Individual Environmental Report Supplemental #6
LAKE PONTCHARTRAIN AND VICINITY,
EAST CITRUS LAKEFRONT LEVEE
ORLEANS PARISH, LOUISIANA

**FINAL INDIVIDUAL ENVIRONMENTAL REPORT
SUPPLEMENTAL**

EAST CITRUS LAKEFRONT LEVEE

IERS #6

Figure 1: Conceptual design for addition of floodwall to LPV 105.02. All dimensions are approximate.

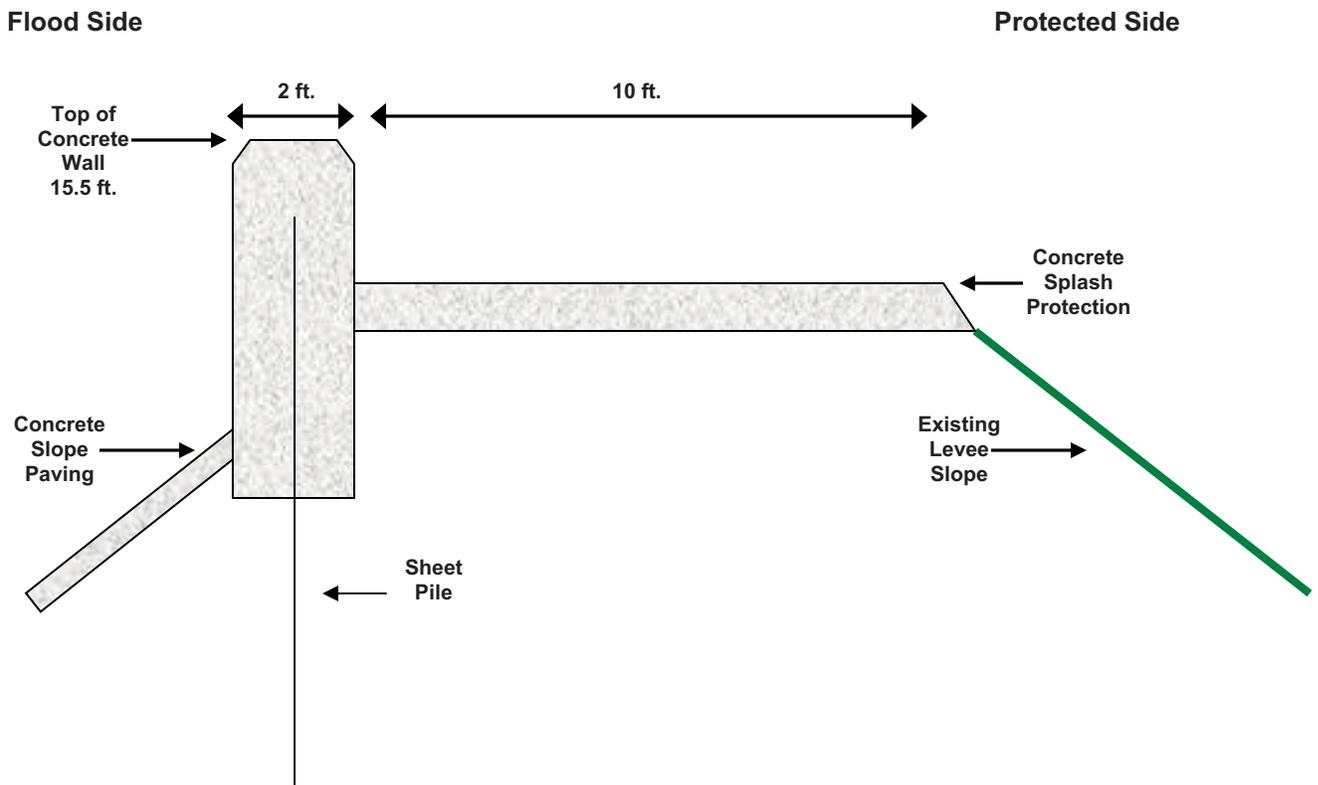
The substitution of an I-wall placed near the crown of the existing earthen levee is a compromise of the structural integrity of the planned flood protection. First, though the stated elevation of the I-wall is 2.5 above the proposed raised levee, the I-wall does not resist overturning loads as a widened levee would. For example refer to the 50 plus levee breaches in New Orleans in August 2005.

Secondly, the sheet pile must be able to resist the bending load applied to it by the hydrostatic pressure of the lake water. Is the section modulus of the sheet pile capable of resisting this overturning moment?

Thirdly, the proposed altered design relies on both the earthen levee as well as the sheet pile being driven to a depth which allows the soil pressure on the lake side of the pile to resist this overturning moment. This requires an earthen levee that is substantial in width and height and piles driven to a substantial depth.

The substitution of an I-wall placed near the crown of the existing earthen levee is a compromise of the structural integrity of the planned flood protection. First, though the stated elevation of the I-wall is 2.5 above the proposed raised levee, the I-wall does not resist overturning loads as a widened levee would. For example refer to the 50 plus levee breaches in New Orleans in August 2005.

Secondly, the sheet pile must be able to resist the bending load applied to it by the hydrostatic pressure of the lake water. Is the section modulus of the sheet pile capable of resisting this overturning moment?

Thirdly, the proposed altered design relies on both the earthen levee as well as the sheet pile being driven to a depth which allows the soil pressure on the lake side of the pile to resist this overturning moment. This requires an earthen levee that is substantial in width and height and piles driven to a substantial depth.

The I-wall proposed action is designed to the new HSDRRS guidelines resulting in considerably deeper sheet piling than those used in the breached I-walls. A key design element is the cut-off of seepage potential through and beneath the existing levee. The I-wall solution serves this purpose. The proposed design meets all required factors of safety including those for overturning. In fact to meet the seepage cut-off requirement, the sheet pile is being driven much deeper than required by design. The proposed I-walls stick-up approximately 2 feet above the levee as opposed to the approximately 10 feet of I-wall stick-up above the levee in the breached sections, therefore the comparison between the two systems is not accurate. In addition, the proposed action includes levee armoring on the protected side of the wall. All of these considerations result in a more robust system to provide the 100-year level of risk reduction than that which existed pre-Katrina.

Deep soil mixing was proposed in the original levee design to compensate for the added load of additional fill material to raise the levee. Because the new wall design is supported and no additional load would be added to those soils which were originally in need of subgrade improvements, deep soil mixing is no longer necessary.
